# City of Alexandria, Virginia

## MEMORANDUM

**DATE:** JANUARY 17, 2024  
**TO:** MAYOR WILSON AND MEMBERS OF CITY COUNCIL  
**FROM:** KARL MORITZ, DIRECTOR; DEPARTMENT OF PLANNING & ZONING  
**SUBJECT:** DSUP #2023-10009, REZ #2023-00003, & MPA #2023-00002/301 North Fairfax Street

SHEET TITLE:  
**EXHIBIT:  
 ROOF LEVEL  
 PENTHOUSES  
 01/08/2024**

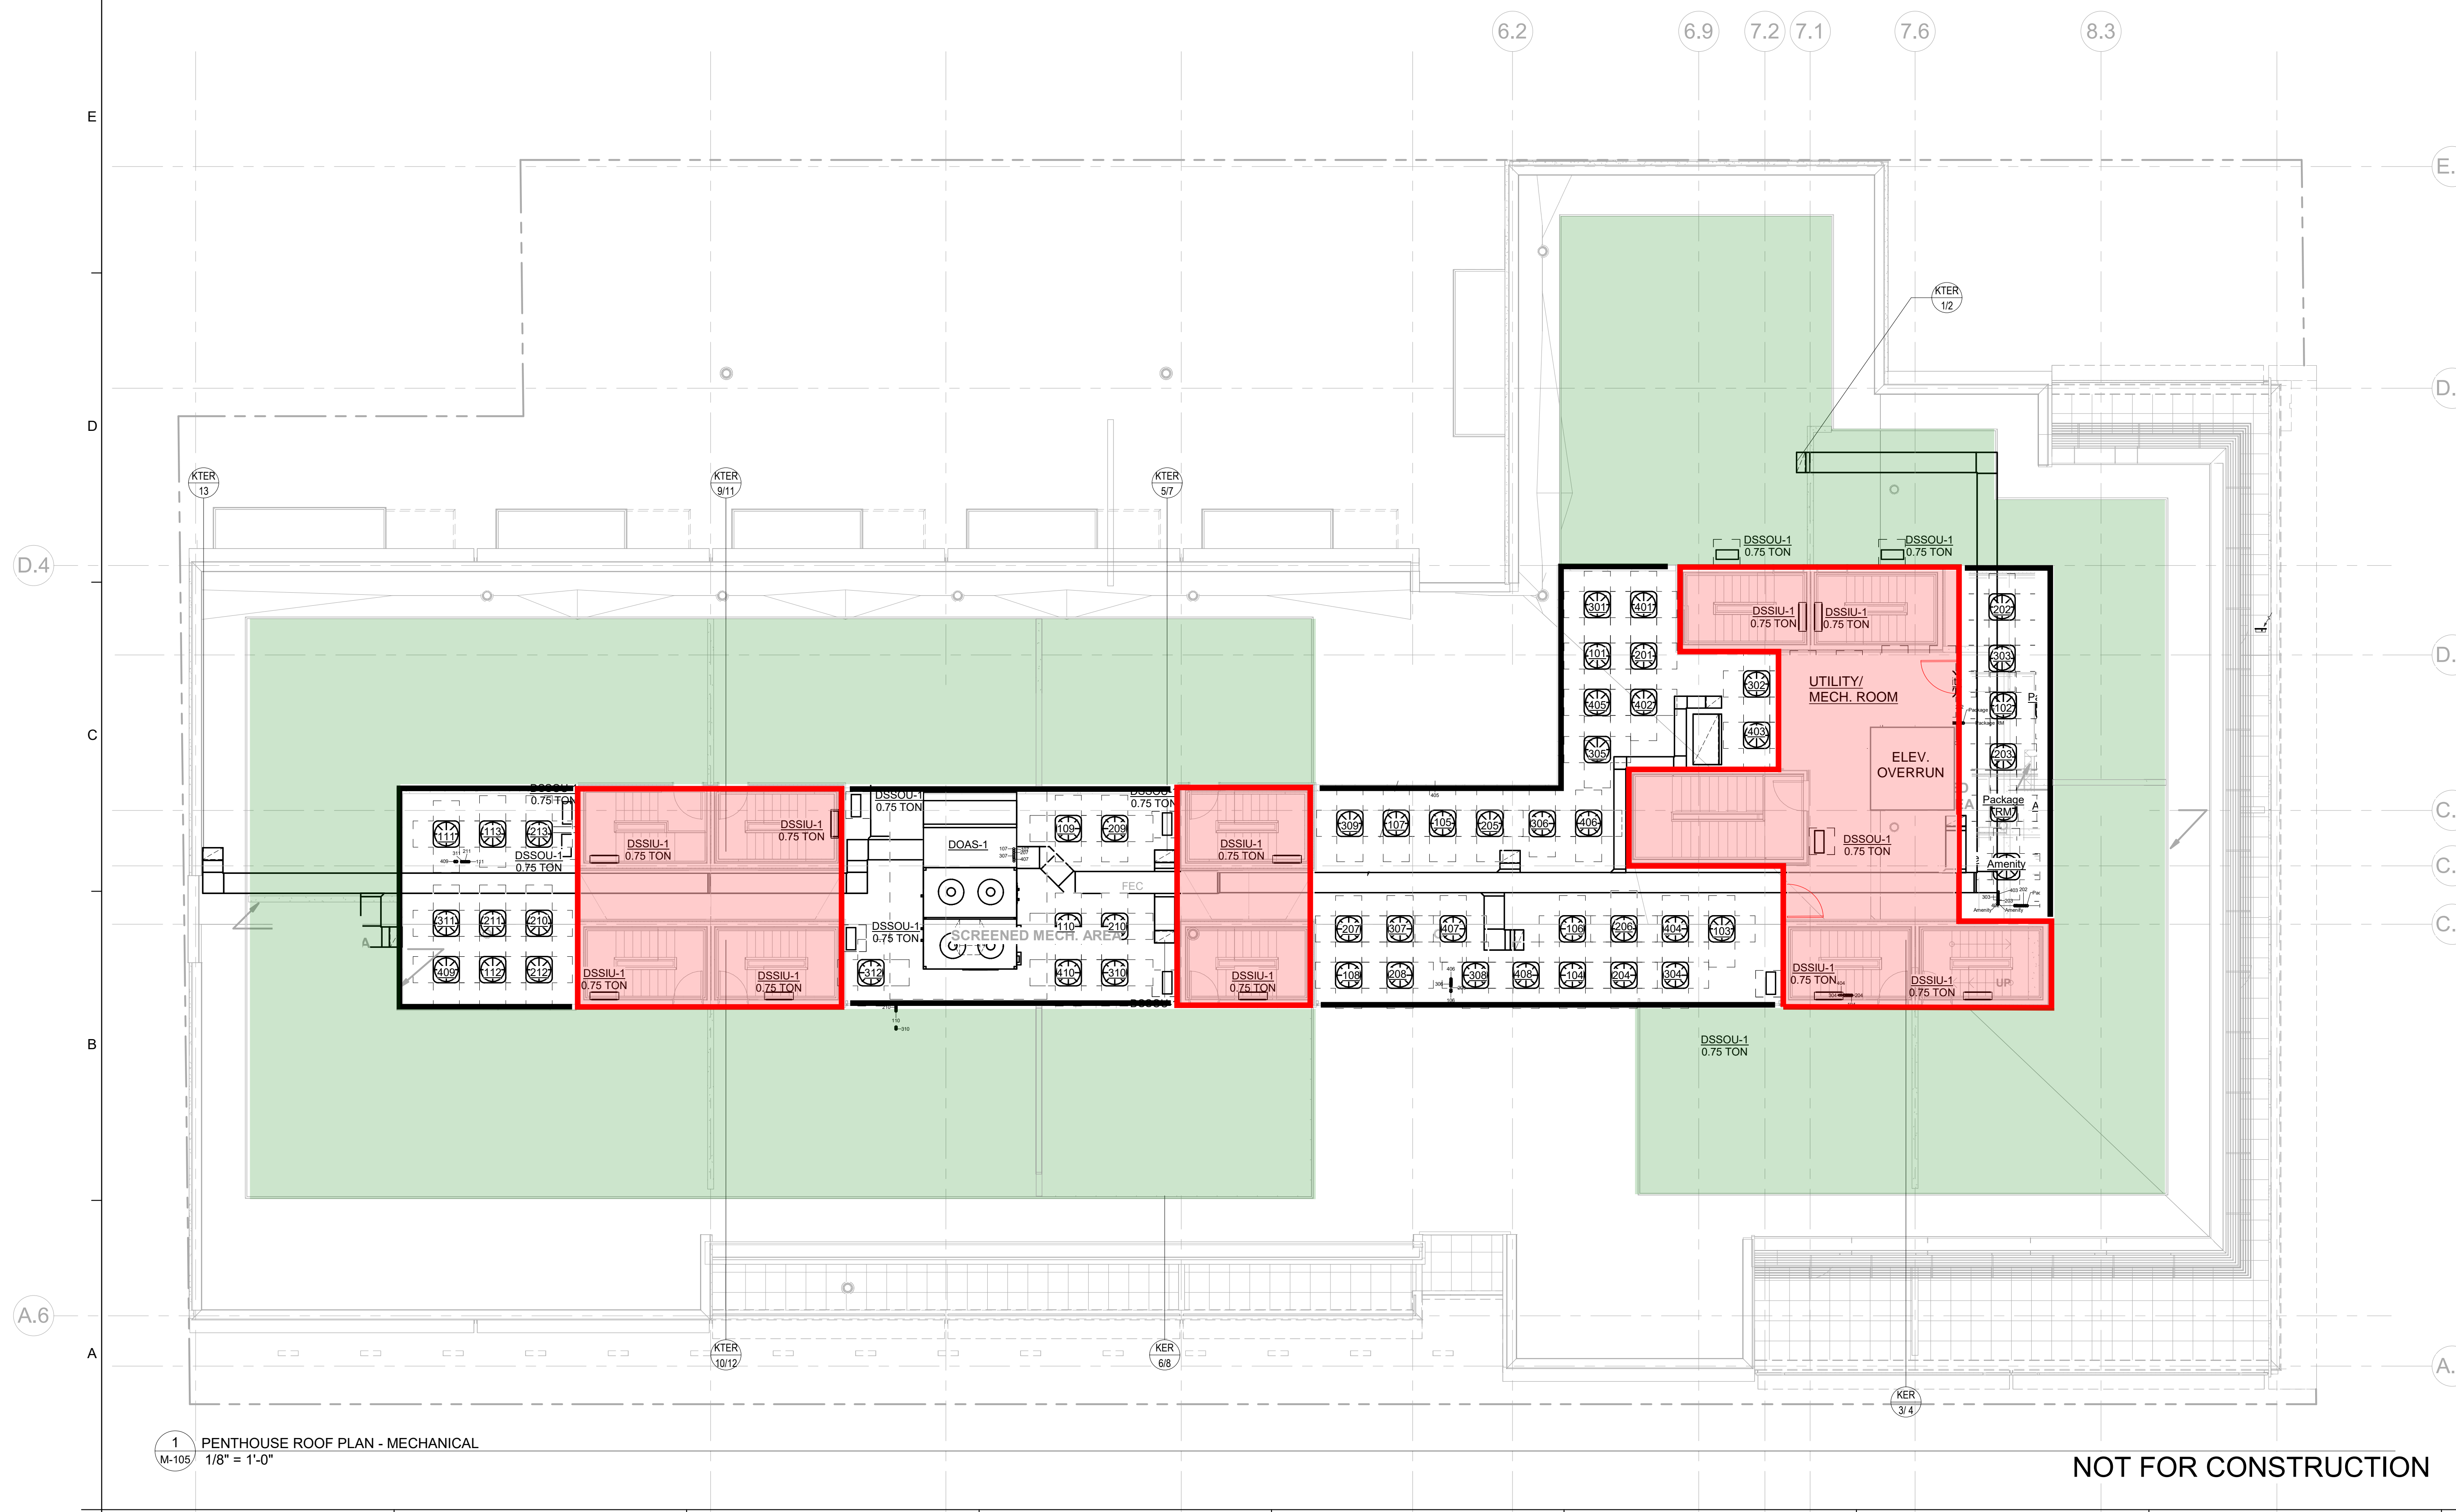
The issue raised in the above referenced letter refers to the Preliminary Plan dated August 22, 2023, and questioned the number of penthouses proposed on the Roof Plan (Sheet A-103). However, on further discussion and review, the yellow boxes that appeared as penthouses are access stairs and not inclusive of the other rooftop mechanical equipment (for example, for an elevator overrun and future electrical panels for solar). The applicant's plans showed the extent of mechanical rooftop screening (9 feet) both in plan and in elevation to illustrate the extent of the penthouses. Penthouses are not included in the height of a building and they are typically set back substantially to minimize their appearance. Planning & Zoning (both Development and BAR) staff work closely with applicants during the Final Site Plan and Certificate of Appropriateness phases to ensure that penthouses and mechanical screening are the minimal size necessary and also architecturally integrated. The applicant has continued the design process for the rooftop mechanical and provided an updated Roof Plan exhibit to confirm that there will be no more than three (3) penthouses in the final building design. Staff will work with the applicant to refine the final design of this element during the Final Site Plan process, which is typically when design elements related to mechanical systems are more fully developed and therefore penthouse equipment and screening are finalized. These details will also be reviewed by the Board of Architectural Review (BAR), who will need to approve any proposed rooftop mechanical screening and penthouses before granting a Certificate of Appropriateness.

- d. Coordinate the design, color, and materials of all penthouses, rooftop mechanical areas, and rooftop screening with the overall architecture of the building, as regards massing, materials, and detailing/expression.
  - i. **No more than three penthouses are permitted without a special use permit pursuant to Section 6-403-(B)(3)(a). The applicant shall work to reduce the overall height of the mechanical screen, as appropriate, in consultation with staff. The general design of the penthouse and rooftop scheme shall be consistent with the Preliminary Plan and updated revision dated January 12, 2024 and finalized during the Final Site Plan process to the satisfaction of the Director of Planning & Zoning.**

**Map 25  
Old Town Land Use Plan,  
as amended**

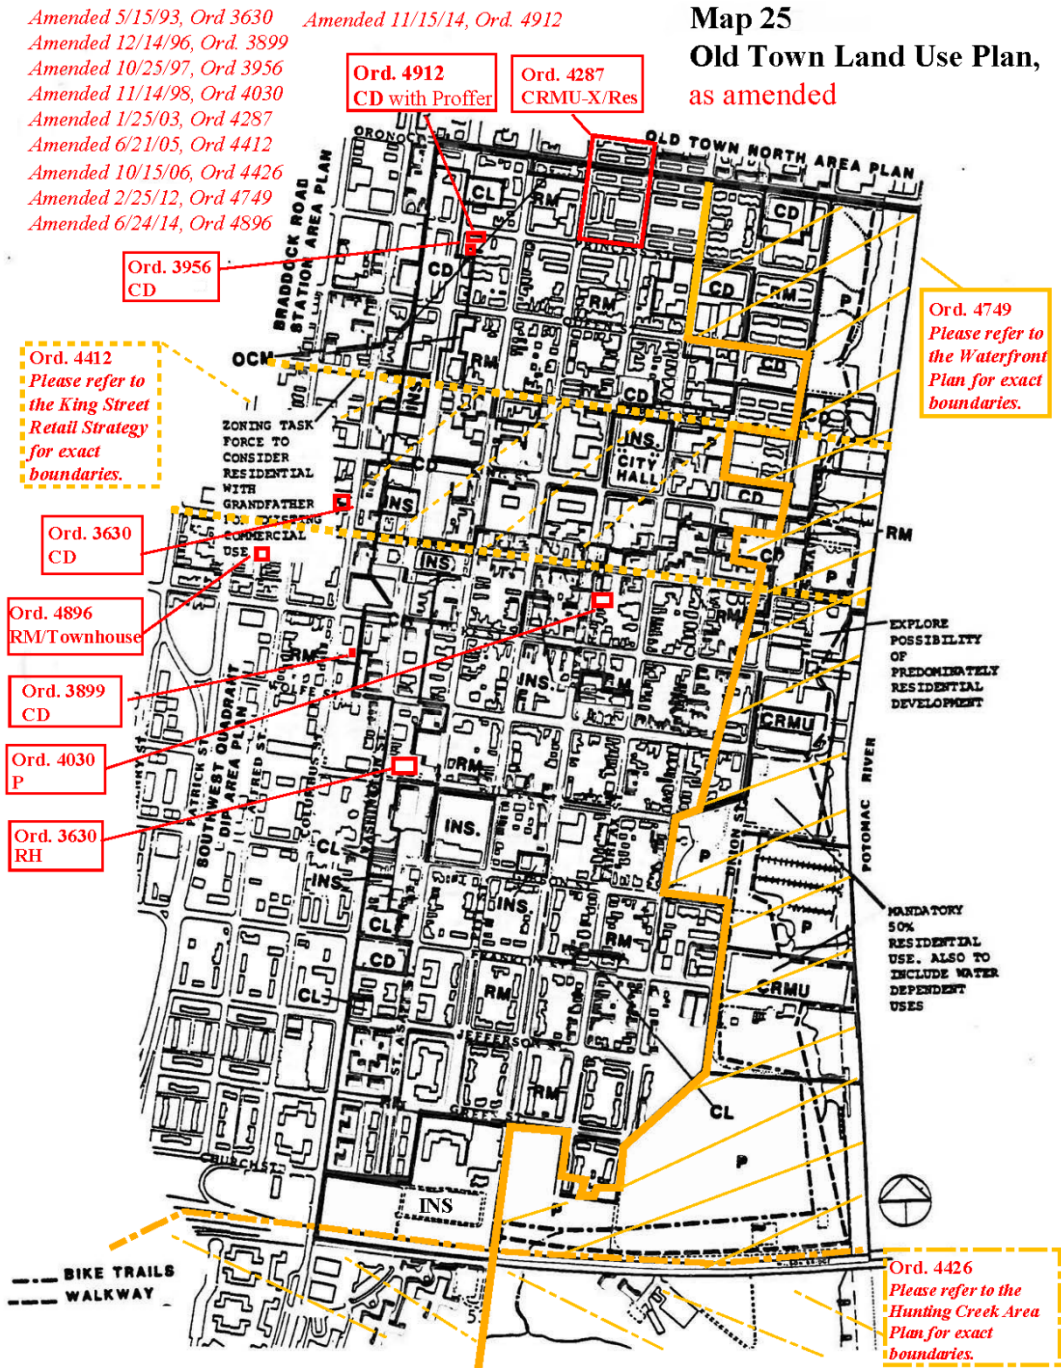
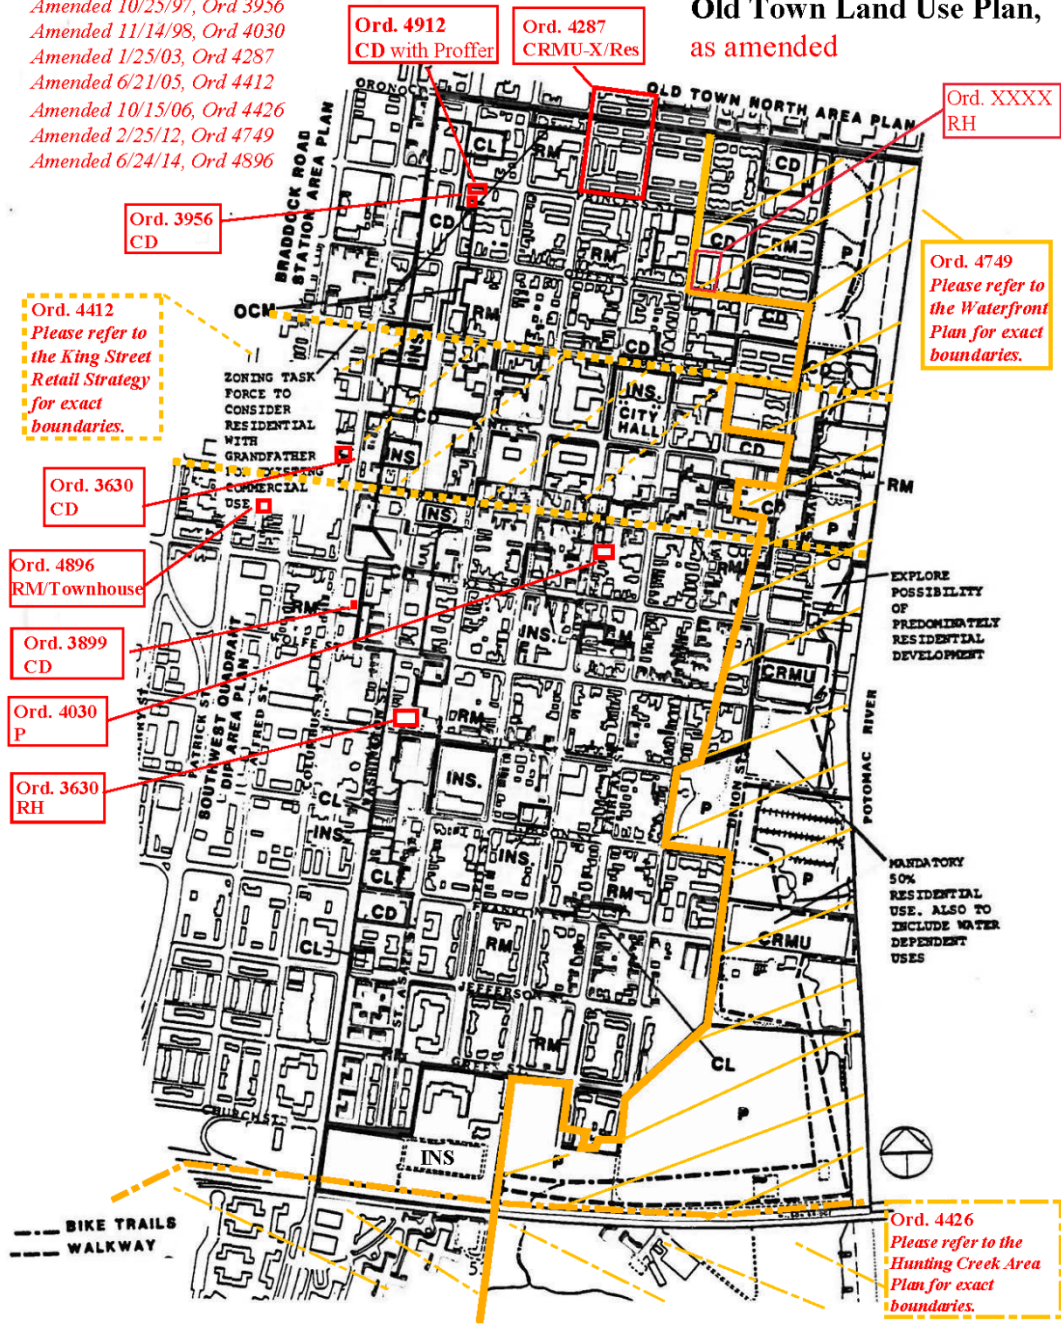
Staff wants to advise you of a clerical error in the reference to the Old Town North Small Area Plan in the Master Plan Amendment Resolution (page 63, paragraph 1 of the staff report) ("the Resolution"). The Resolution is only intended to amend the Old Town Small Area Plan, which is referenced six (6) times throughout the Resolution text, in bold, underlined text. The Planning Commission's discussion and action was clear that they were amending the Old Town Small Area Plan. Additionally, the attached Land Use Maps associated with the Resolution on pages 64 and 65 are official maps from the Old Town Small Area Plan, not the Old Town North Small Area Plan. Staff will ensure that the implementation ordinance that is docketed for Council adoption references the Old Town Small Area Plan.
